the eight one five pine

815 Pine Street
Denny Triangle Urban Center Village
DPD Project # 3007151

Recommendation Meeting Goal:

Obtain final DRB approval to allow the project to move forward to construction.

View of Pine Street and Ninth Avenue Corner

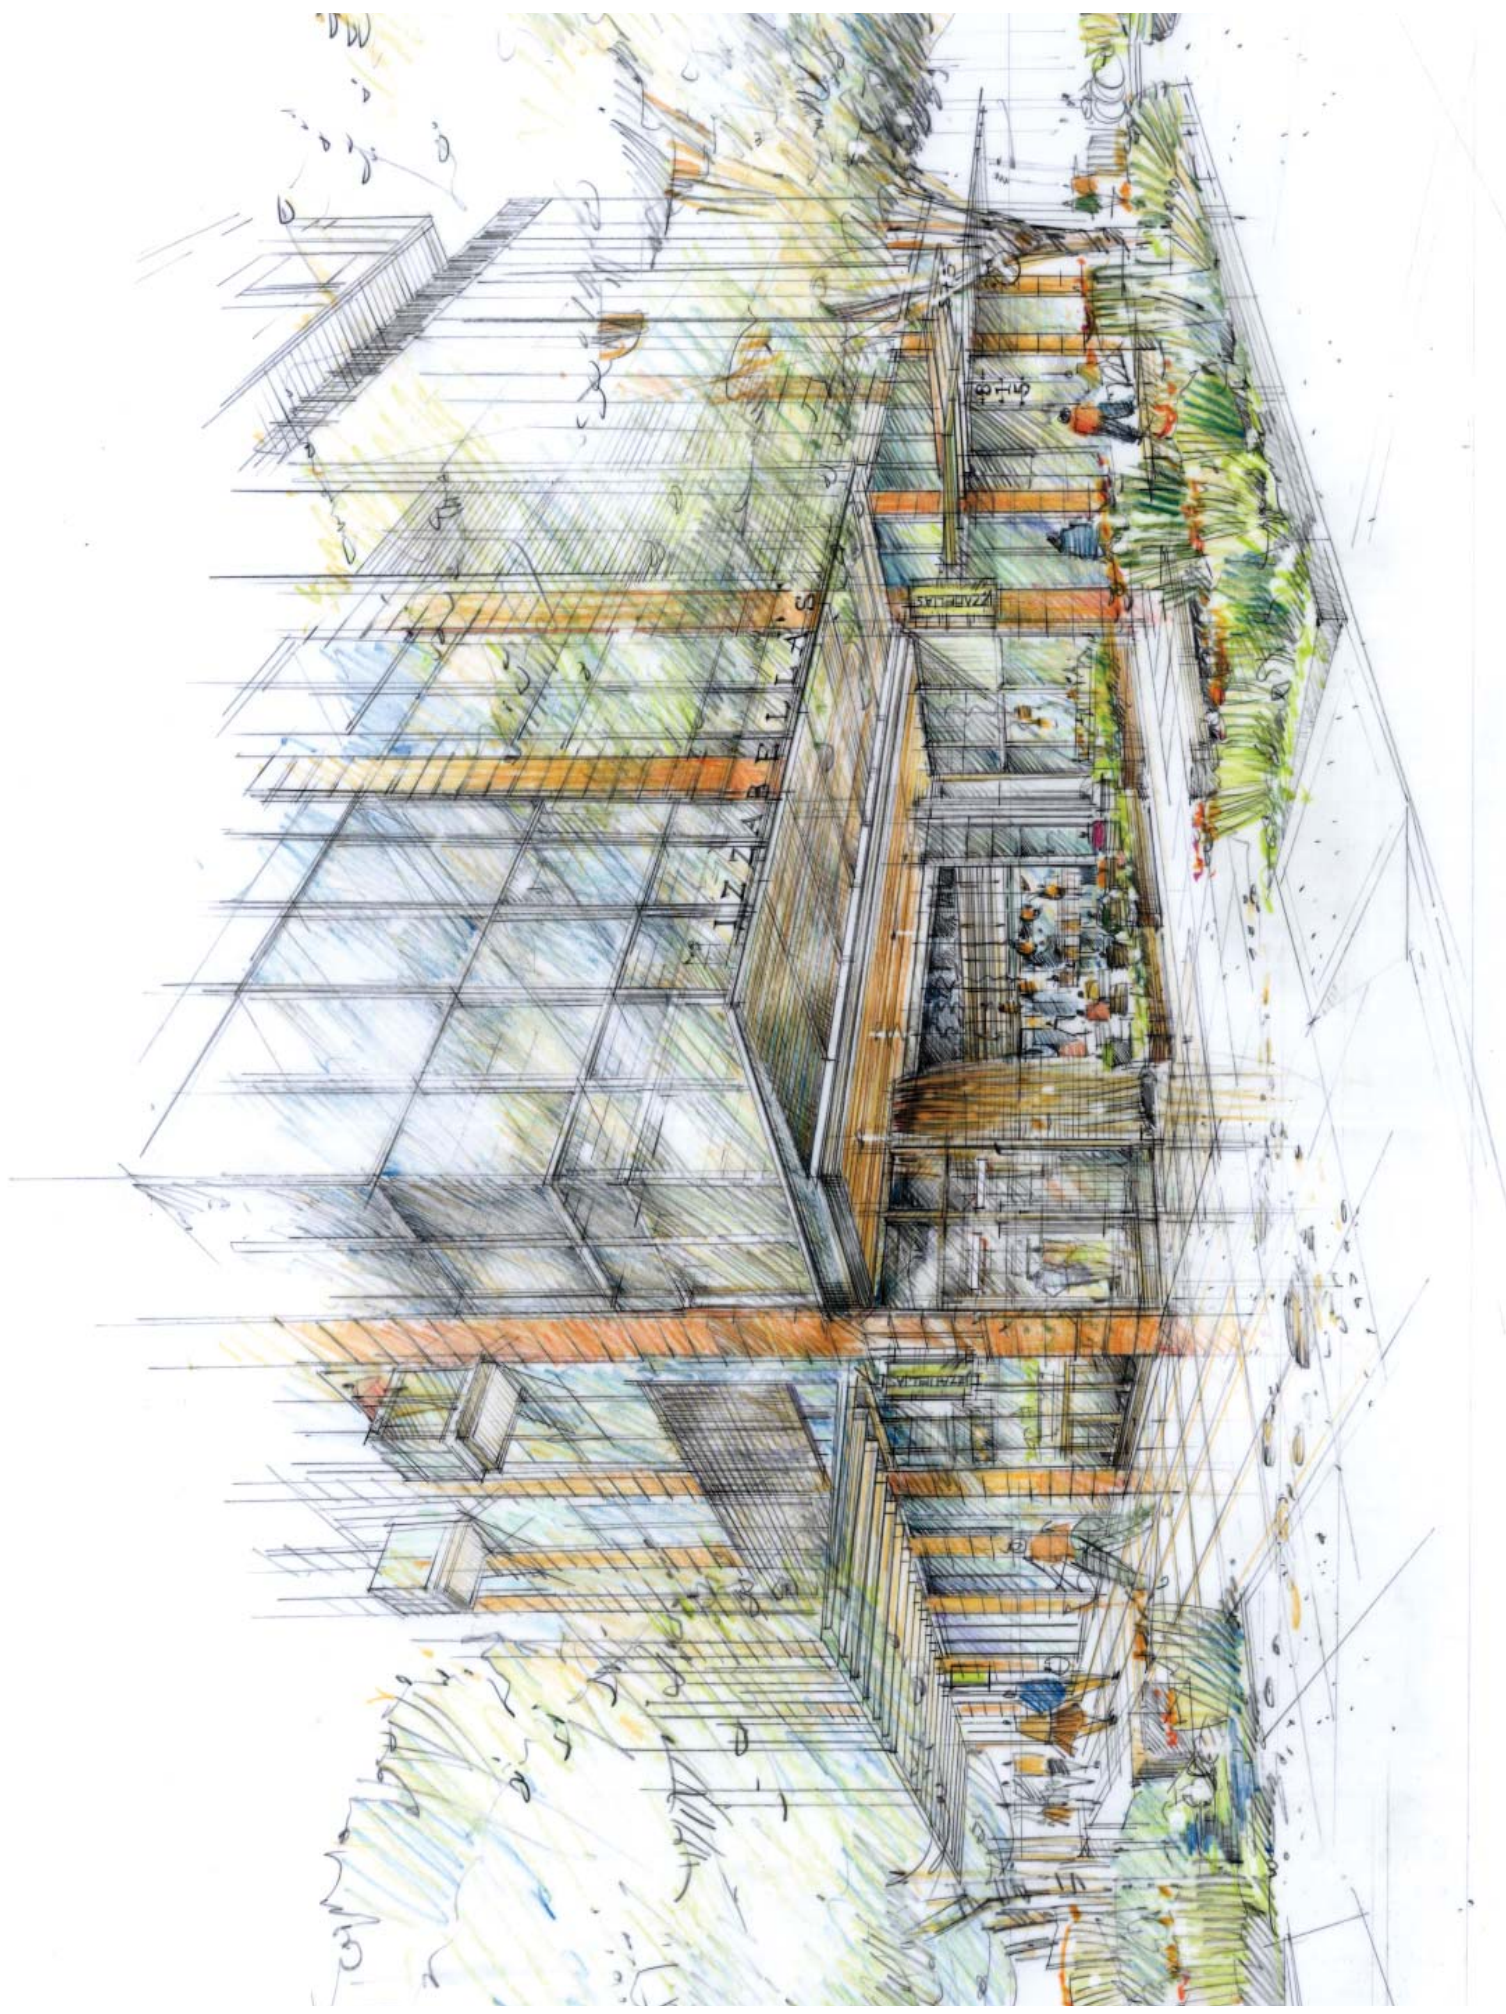
DRB Comments – The idea of a restaurant engaging the interior and exterior of the corner as well as providing activity at two levels interested the Board members. Done right, the design could define the place as an attractive neighborhood feature and complement to the neighboring theater. The Board looks forward to seeing more refinement for the Recommendation meeting.

Response – The coordinated design of the recessed building corner and street landscaping concept will provide an area of respite and sense of place at this important intersection.

Night View of Pine Street and Ninth Avenue Corner

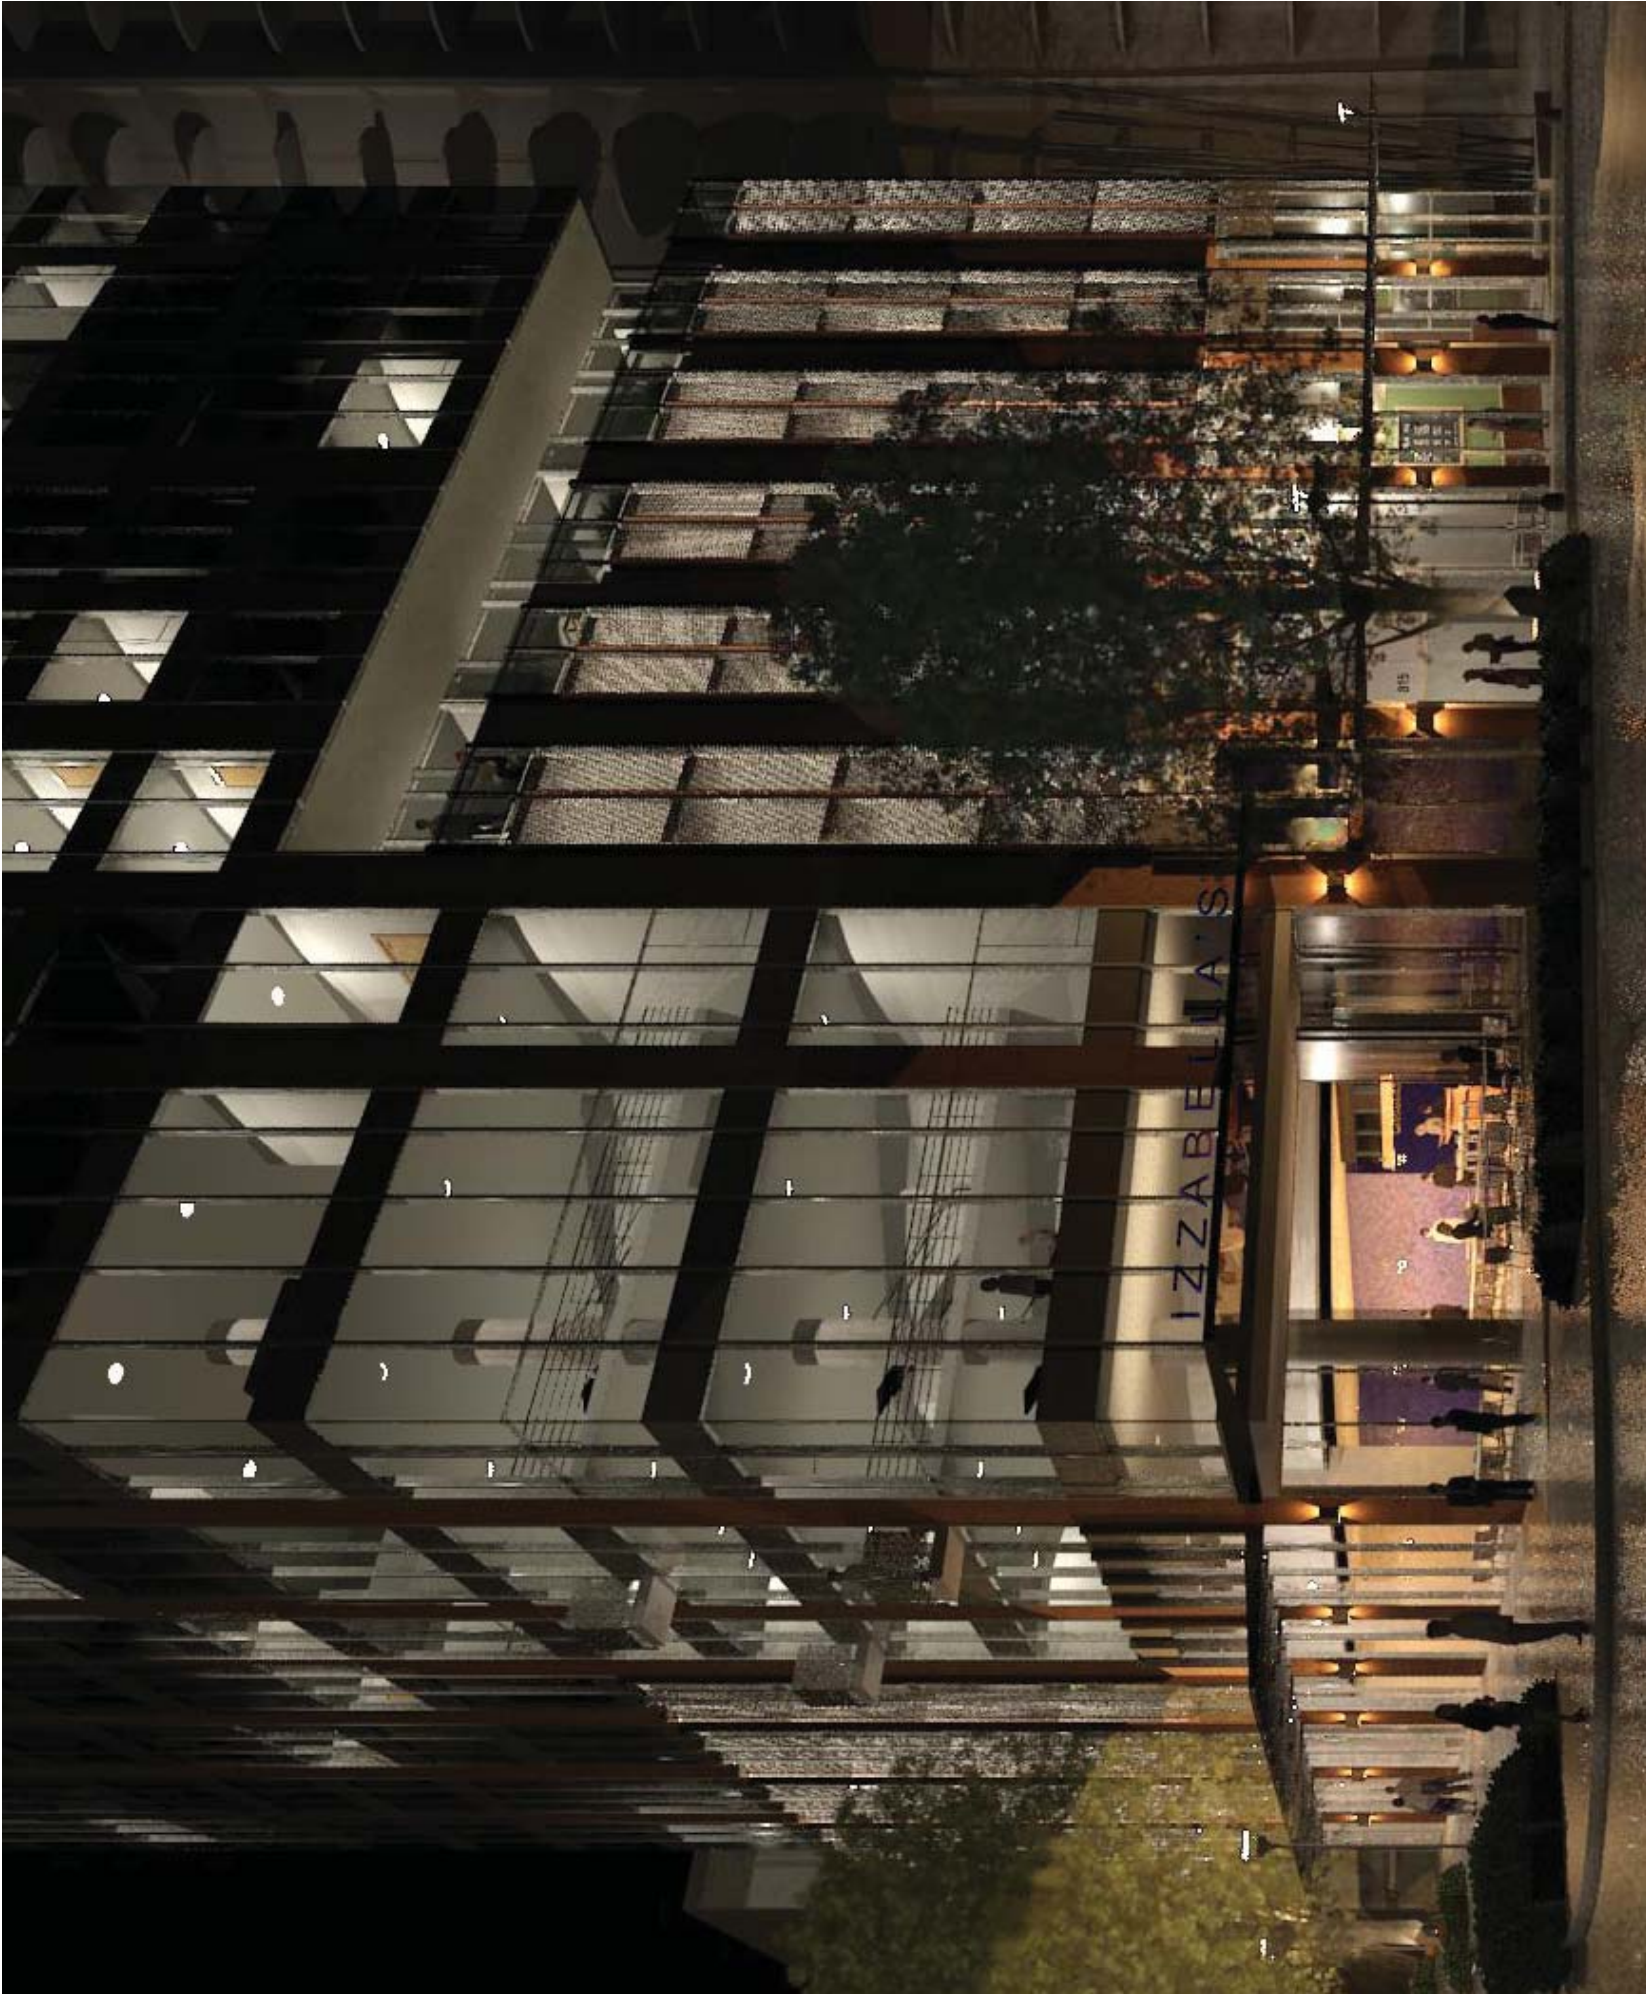
DRB Comments – Basing its remarks on the nighttime renderings, the Board requested suffused illumination at the corner rather than the harsh light as shown on the drawings. Drawings for the next meeting should make this clear.

Response – The primary sidewalk lighting will be provided by the tall 20'+ high storefront windows. The glass canopies will maximize the amount of this light that spills upon the sidewalk. Above the sidewalk the parking screen will be lit with continuous vertical LED lighting that will wash both the inside and outside of the screen. The unique 'egg crate' design of the mesh was specifically chosen for its ability to capture and reflect light. The lighting of the tower top will highlight the balcony and curtain wall high above the Pine Street and Ninth Avenue corner. This corner focal point will be flanked by a gentle glow of the stainless steel mesh mechanical screen lighting similar to the base.
